Subject:
New cable entry for Mega

Date:
Jan 21, 2014

Technical Newsletter

No:
53

Figure 1. New cable entry.

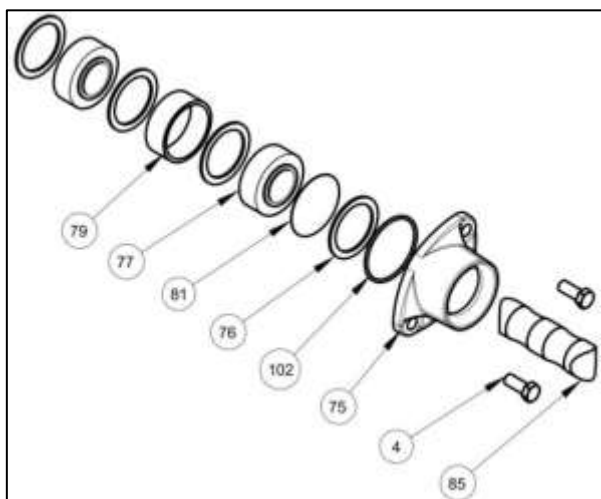
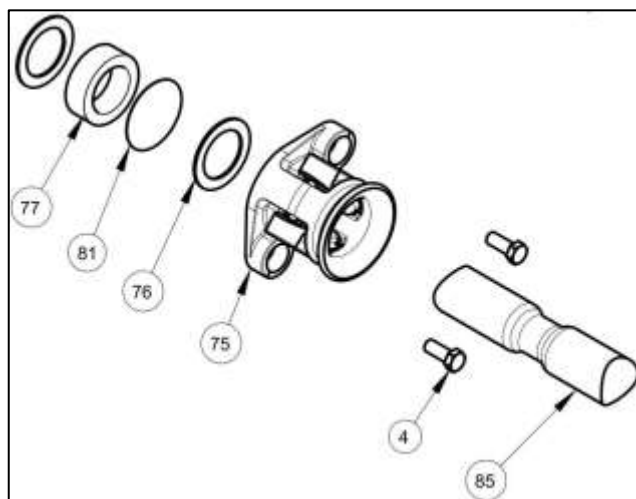
The cable entry used in Mega 8124 has been changed to a new double seal sleeve entry, delivered with all pumps from production cycle 2014-2.

The main difference between the new cable entry, see figure 1, and the old, see figure 2, is the strain relief which consist of a second seal sleeve instead of the clamps used in the old. This design will lead to a more evenly distributed deformation of the cable. The strain relief seal sleeve will also work as an extra seal and make the entry more redundant.

The new cable entry uses a different set of seal sleeves than the old, see table 2. Note that each entry uses two sleeves and four washers.
